Metropolitan Historic Zoning Commission
Sunnyside in Sevier Park
3000 Granny White Pike
Nashville, Tennessee 37204
Telephone: (615) 862-7970
Fax: (615) 862-7974

STAFF RECOMMENDATION
1724 Linden Avenue
November 19, 2018

Application: New Construction—Addition; Setback Determination
District: Belmont-Hillsboro Neighborhood Conservation Zoning Overlay
Council District: 18
Map and Parcel Number: 10416016500
Applicant: Van Pond, Jr.
Project Lead: Melissa Sajid; melissa.sajid@nashville.gov

1 Proposed Site Plan

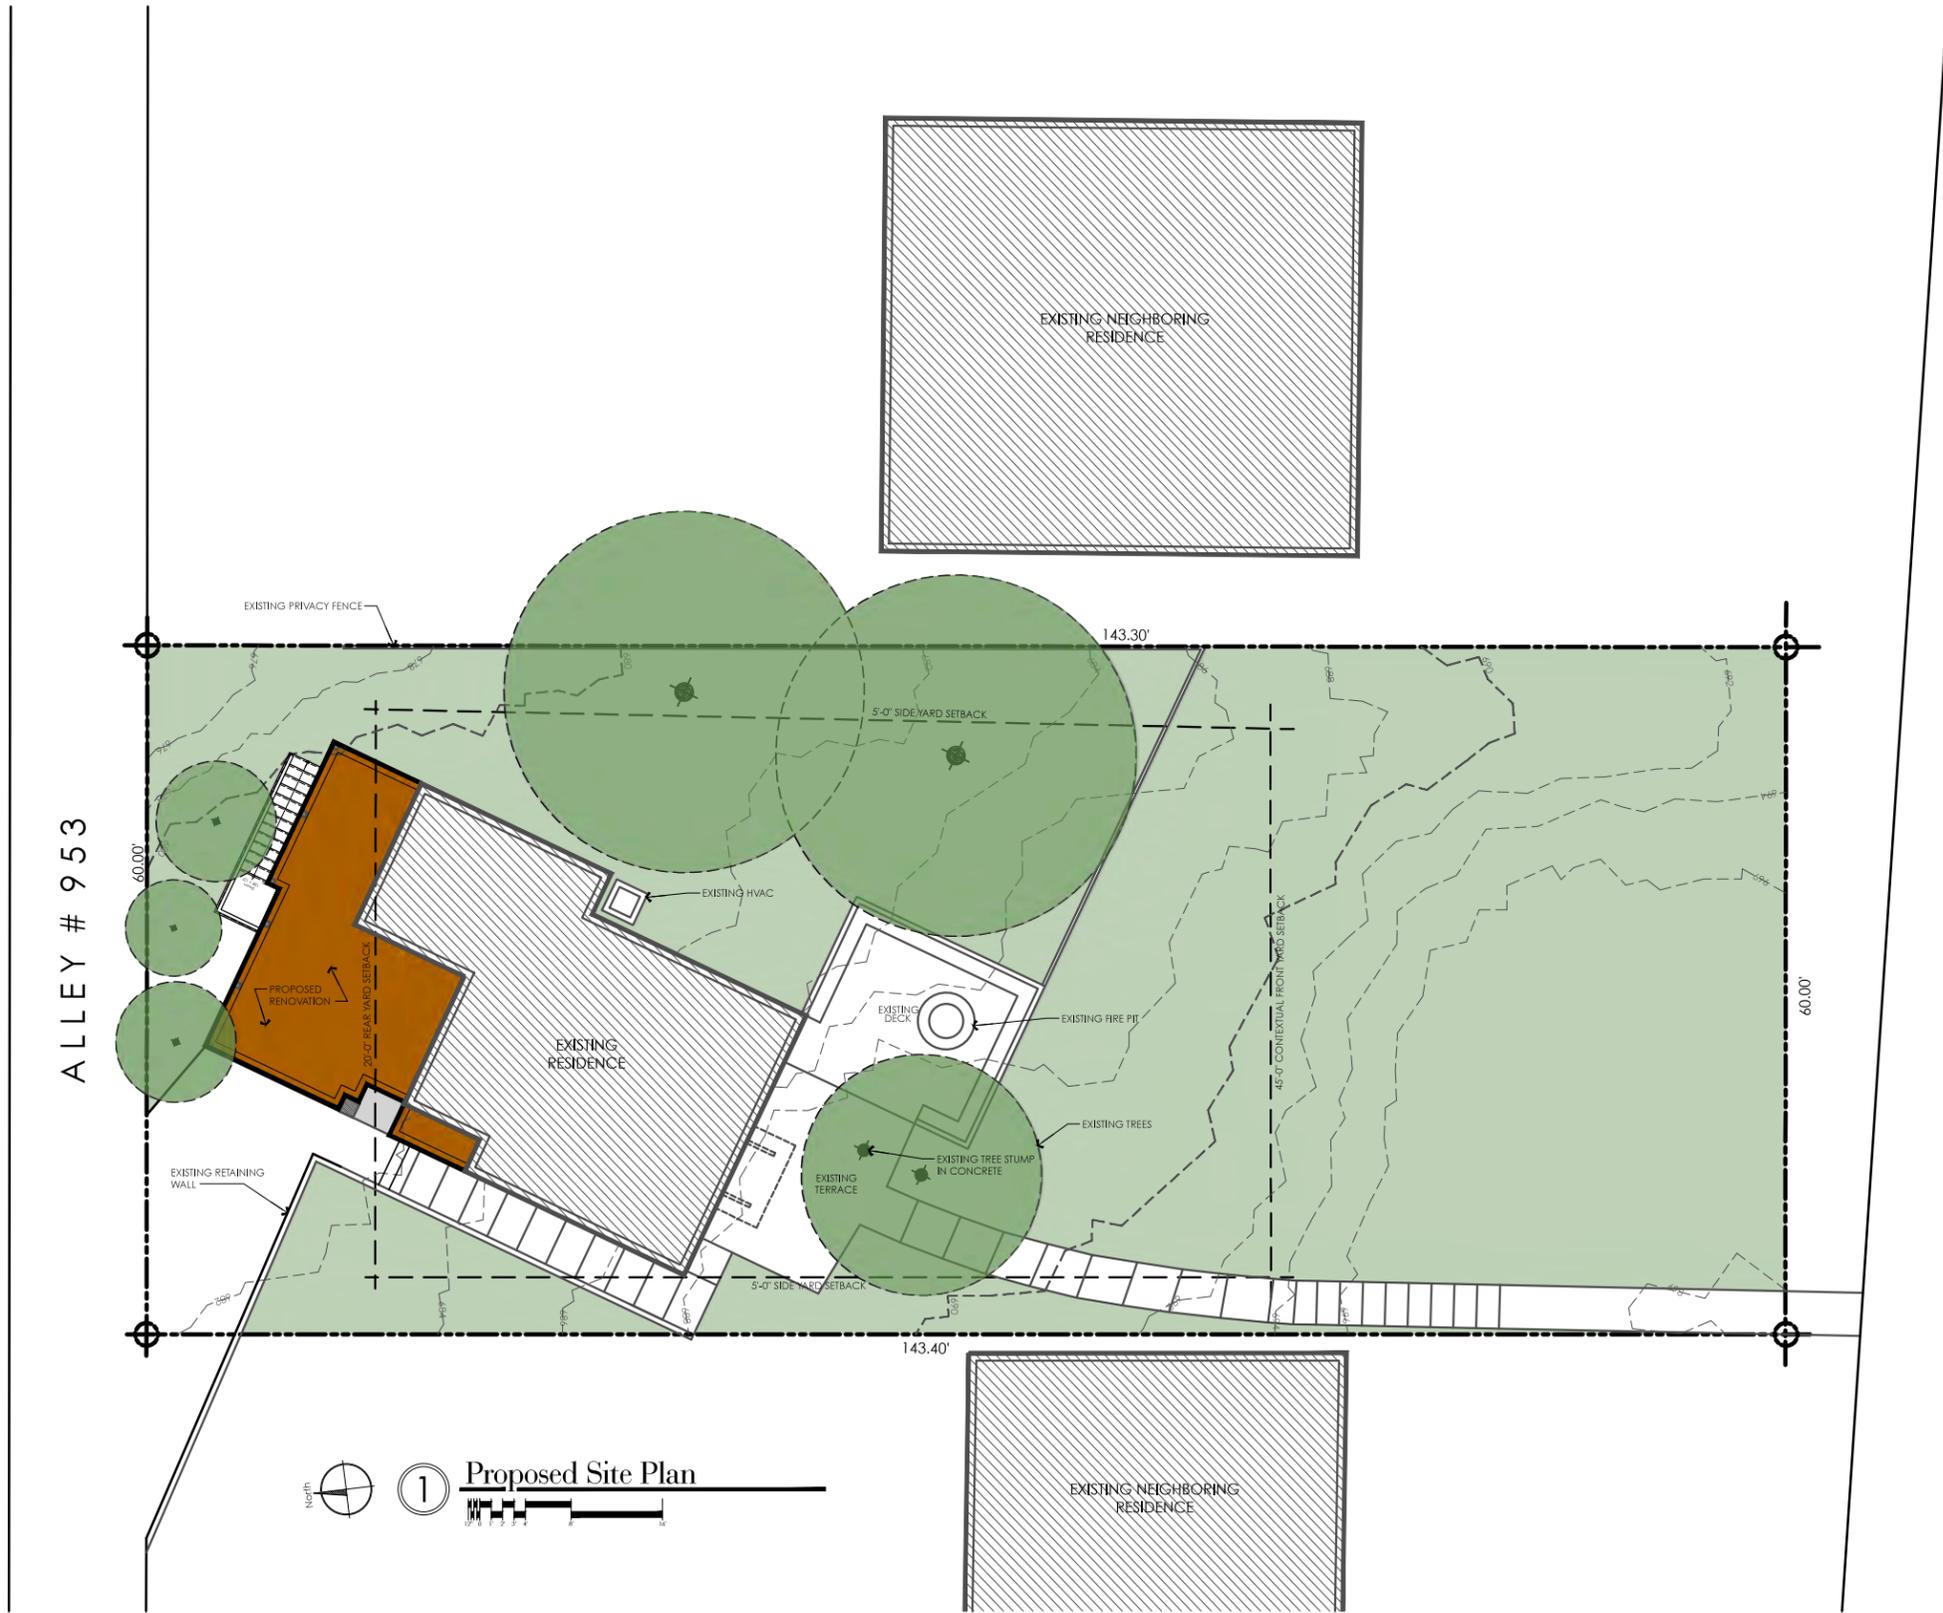
Setback & Rhythm of Spacing: The exterior staircase addition will be nine feet (9') and thirty-six feet (36') from the right and left sides, respectively, and will be six feet (6') from the rear property line. The addition meets base setback requirements of five feet (5') on the sides but does not meet the twenty feet (20') setback at the rear.

The applicant has requested a setback determination to reduce the rear setback from twenty feet (20') to six feet (6'). Staff finds the setback determination appropriate in this case since the house is located at the rear of the lot. Furthermore, the existing rear addition is approximately five feet (5') from the rear property line, so the proposed uncovered stairs will be no closer than the existing house. For these reasons, staff recommends approval of the rear setback determination and finds that the project meets Section II.B.1.c.

DATE OF ISSUANCE:
31 October 2018
PROPOSED SIDE + REAR ELEVATION:

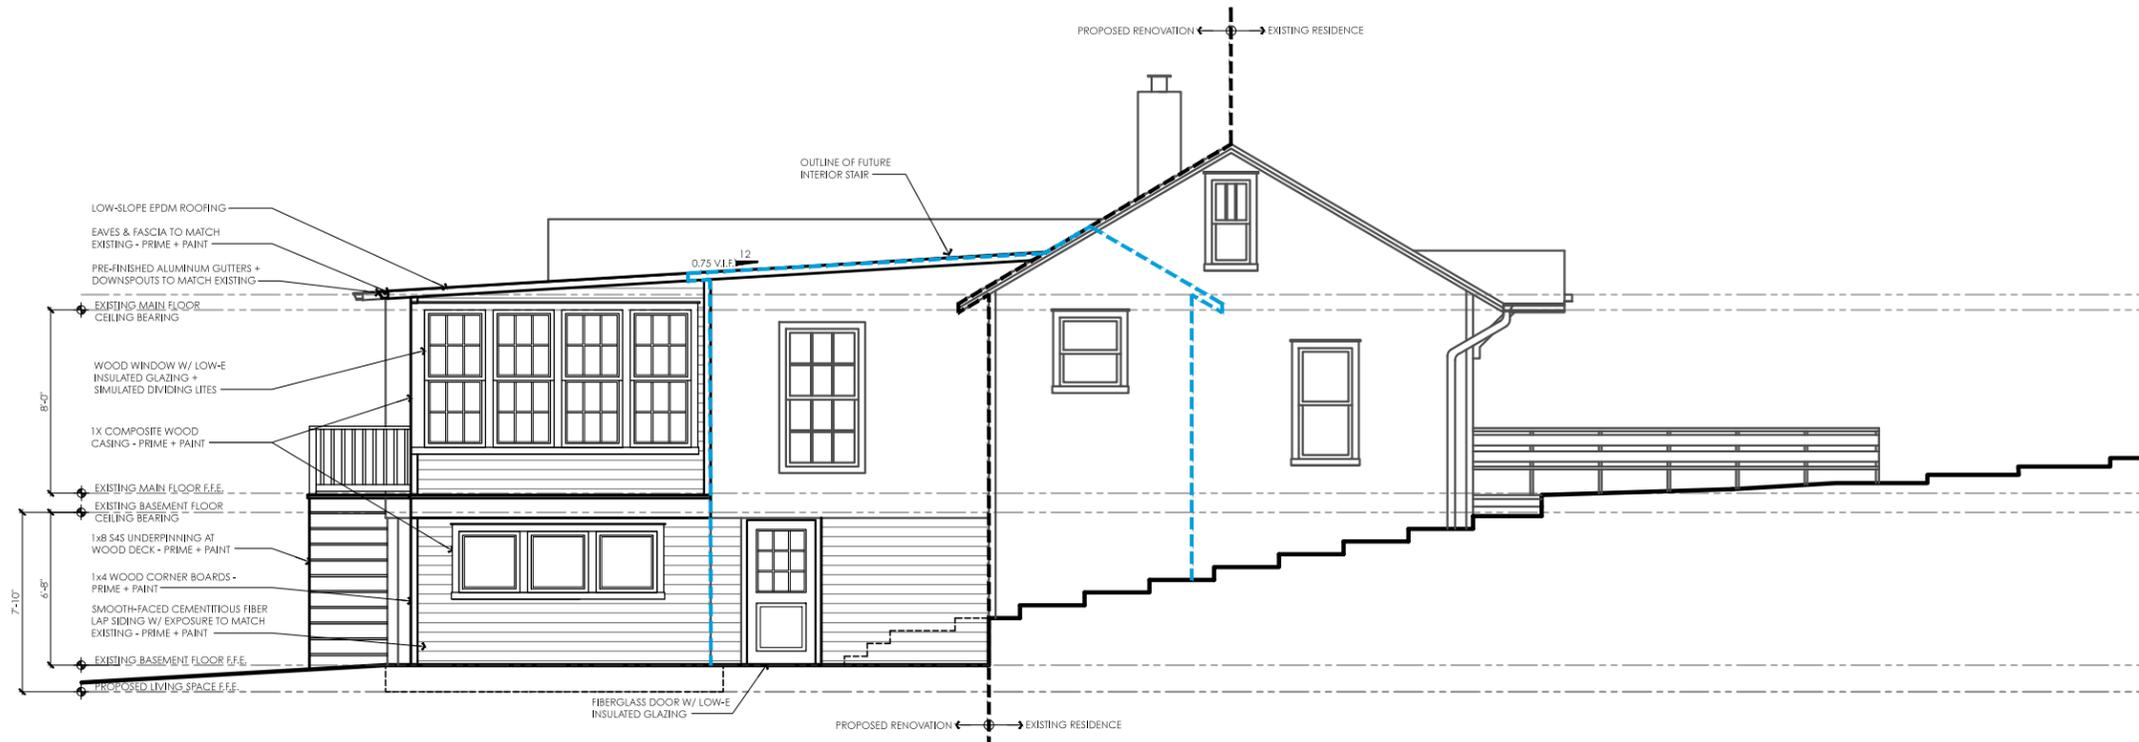
The enclosed rear porch will be clad in smooth faced lap siding with a reveal to match the house. The plan proposes to continue the siding to grade. While a more appropriate foundation material is usually required for basement level additions, staff finds that the lap siding to grade could be appropriate in this case since the house and addition are located so far back on the rear of the lot. With staff approval of roof color and windows, the project meets Section II.B.1.d for materials.

Proportion and Rhythm of Openings: The application does not include any changes to the window and door openings on the existing house. The windows on the proposed porch enclosure are generally twice as tall as they are wide, meeting the historic proportion of openings. There are no large expanses without a window or door opening. Staff finds the project’s proportion and rhythm of openings to meet Section II.B.1.g.

Recommendation: Staff recommends approval of the enclosure of the rear porch and setback determination with the condition that staff approve the roof color and windows prior to purchase and installation.
